UNITED STATES PATENT AND TRADEMARK OFFICE

APPLICATION NO.	FILING DATE	FIRST NAMED INVENTOR	ATTORNEY DOCKET NO.	CONFIRMATION NO.
10/732,707	12/10/2003	Andrea Wooten	DMJ0302100	2081
7590 12/30/2005			EXAMINER	
Delphine M. James Attorney-at-Law Suite 170 2656 South Loop West Houston, TX 77054			HALE, GLORIA M	
			ART UNIT	PAPER NUMBER
			3765	
DATE MAILED: 12/30/2005

DETAILED ACTION

FIG. 1

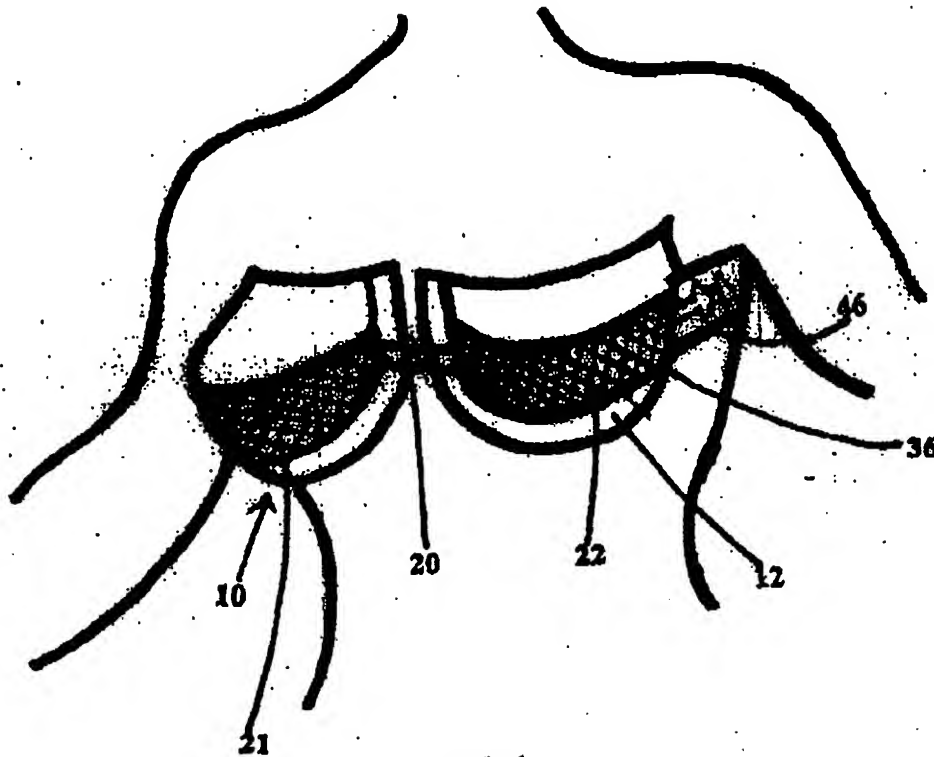
The drawing correction received on 8-8-05 has been approved.

Approved
08/10/25/05
